NOD_SCE_ATJ_20211202-01

NOTICE OF DEFECT

Energy Safety Inspection Report

Report Name: ATJ_SCE_20221202-01

Structure ID: 4628153E

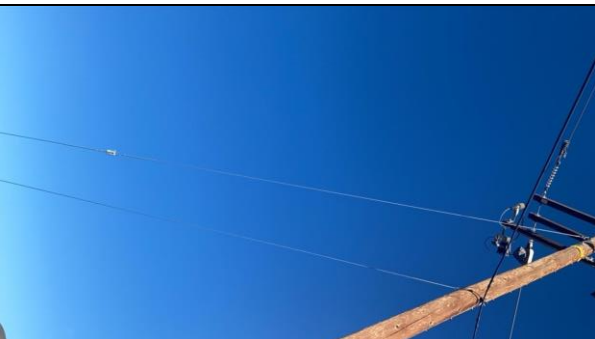
Item2IA1Img1: No vibration dampers

Item2IA3Img1: No bolted wedge connector covers when transitioning from bare to covered conductor

Item2IA4Img1: Porcelain down guy

Structure ID: 710834E

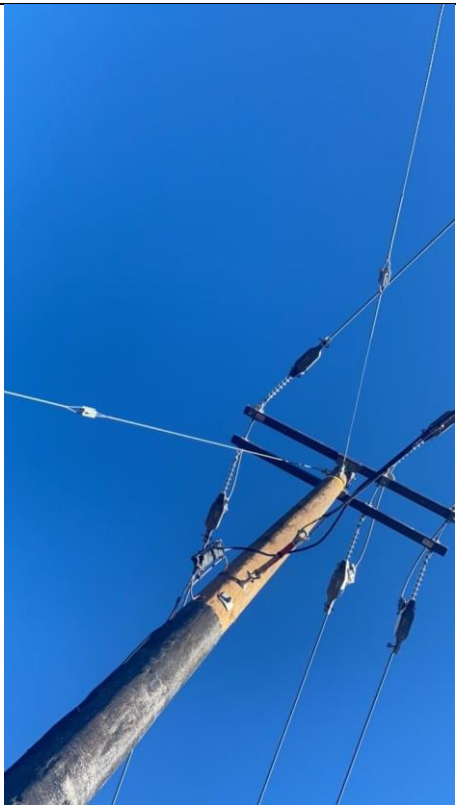
Item3IA1Img1: No vibration dampers

Item3IA2Img1: Porcelain guy insulators

Structure ID: 862693E

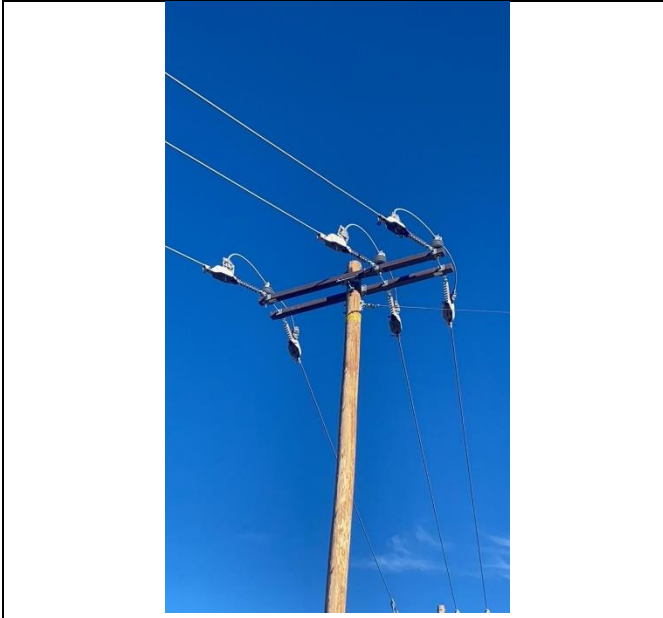
Item4IA1Img1: No vibration dampers

Item4IA2Img1: Porcelain guy insulator

Structure ID: 4724215E

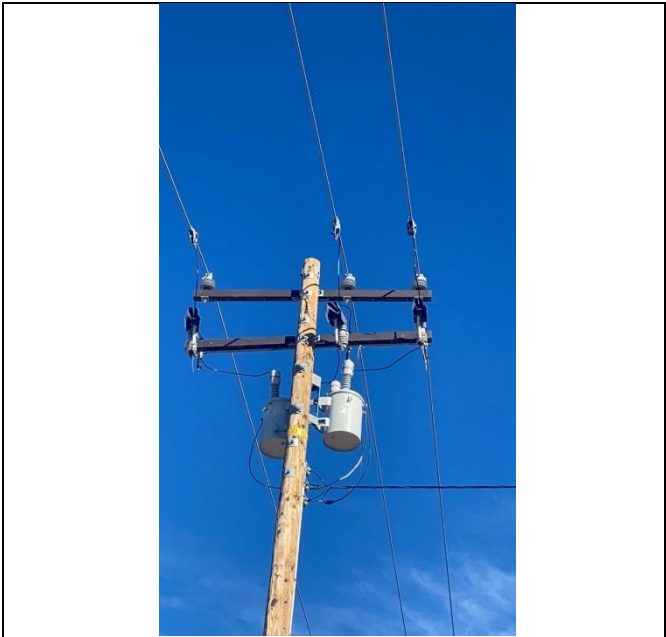
Item6IA1img1: No vibration dampers

Structure ID: 4393705E

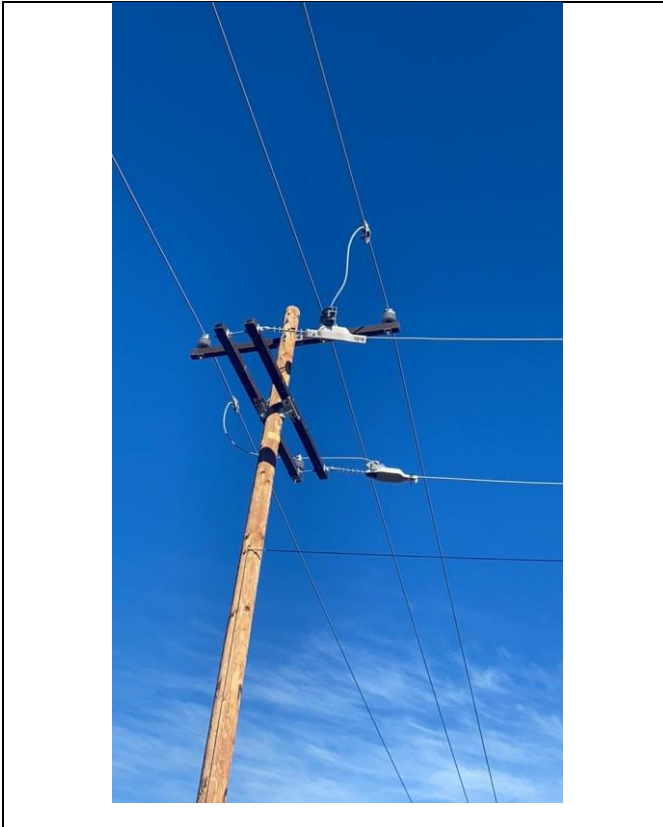
Item8IA1Img1: No vibration dampers

Structure ID: 4393713E

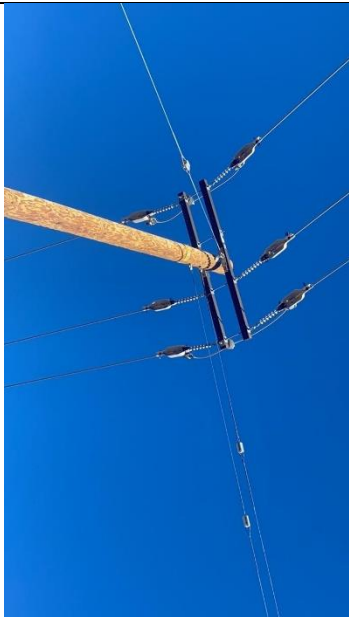
Item9IA1Img1: No vibration dampers

Item9IA2Img1: Three guy wires with porcelain insulators

Structure ID: 4308815E

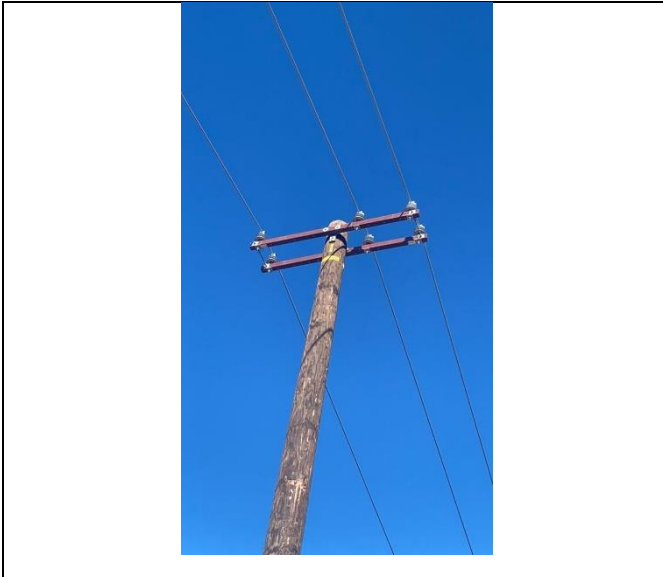
Item10IA1img1: No vibration dampers

Structure ID: 862696E

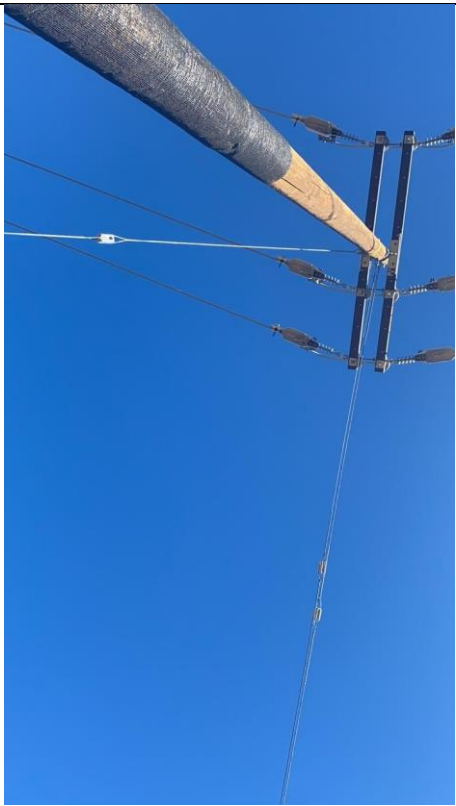
Item11IA1Img1: No vibration dampers

Item11IA2Img1: Porcelain guy insulators on three guys

Structure ID: 4308816E

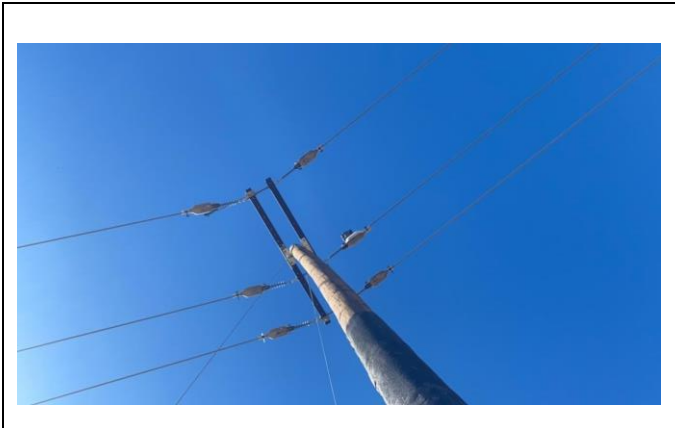
Item12IA1Img1: No vibration dampers

Item12IA2img1: Porcelain guy insulators on two guy wires

Structure ID: 4789750E

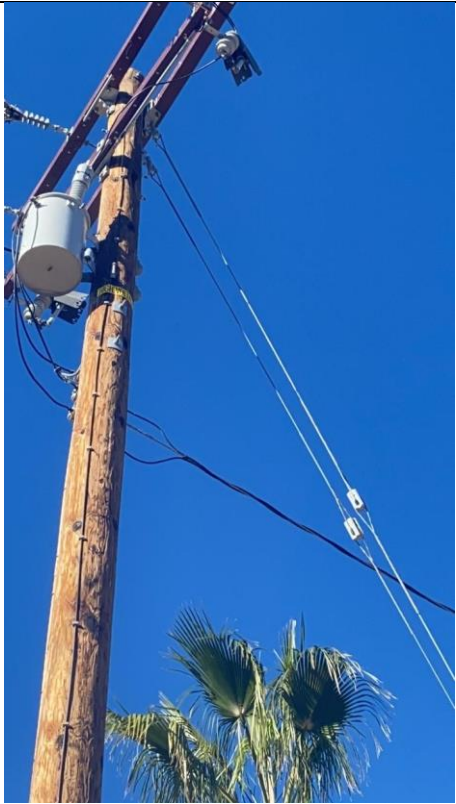
Item14IA1img1: No vibration dampers

Item14IA2Img1: Porcelain insulators

Structure ID: 4568486E

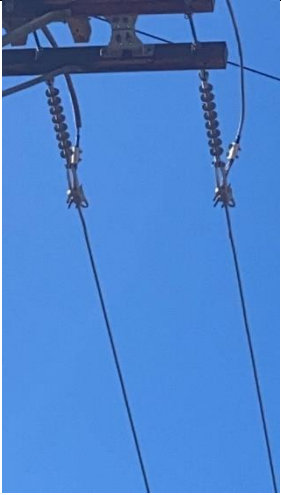
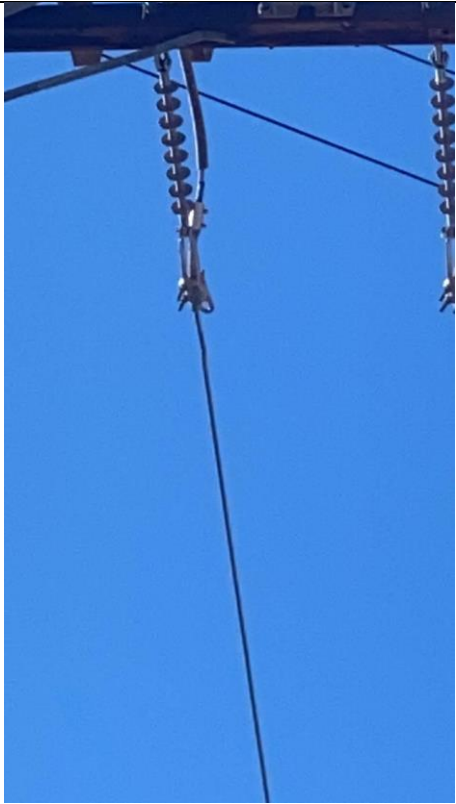
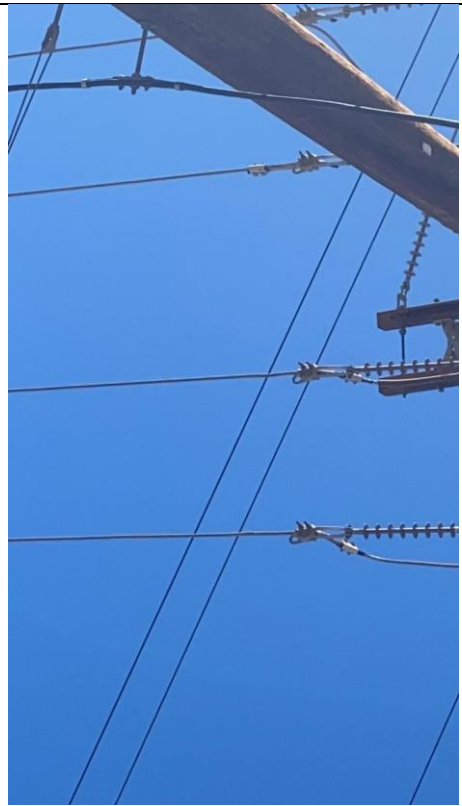
1. Defect 1: Pole numbered 4568486E showed evidence of bird caging on one conductor. Bird-caging refers to the separation of the wires of a stranded conductor. When a conductor is not clamped, tensioned, or terminated properly, the outer wires can open spirally away from the center. Bird-caging on a supply conductor can weaken its strength and lead to a wire down event and ignition. Energy Safety considers this defect to be in the Minor risk category.

Item15CD5Img1: Close up of phase bird caging

Item15CD5Img2: Overall view, bird caging on bottom phase

Structure ID: OH-7017637

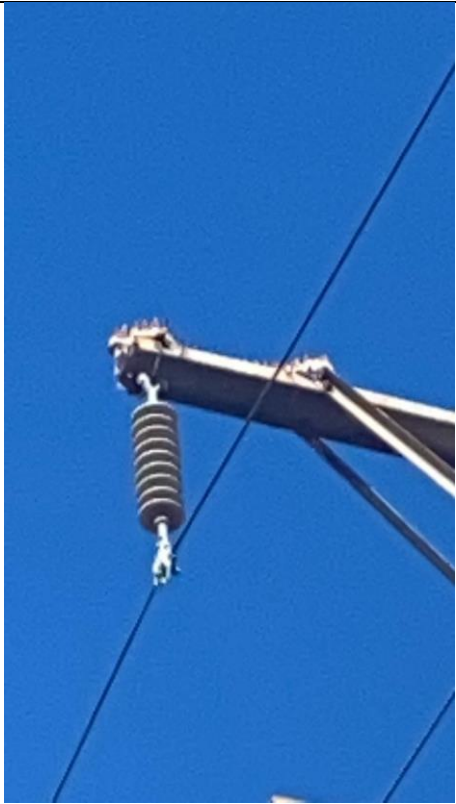
Item16IA1Img1: Bare conductor

Item16IA1Img2: Overall view of bare conductor

Item16IA2Img1: Correct structure ID

Item16IA2Img2: Other structure ID
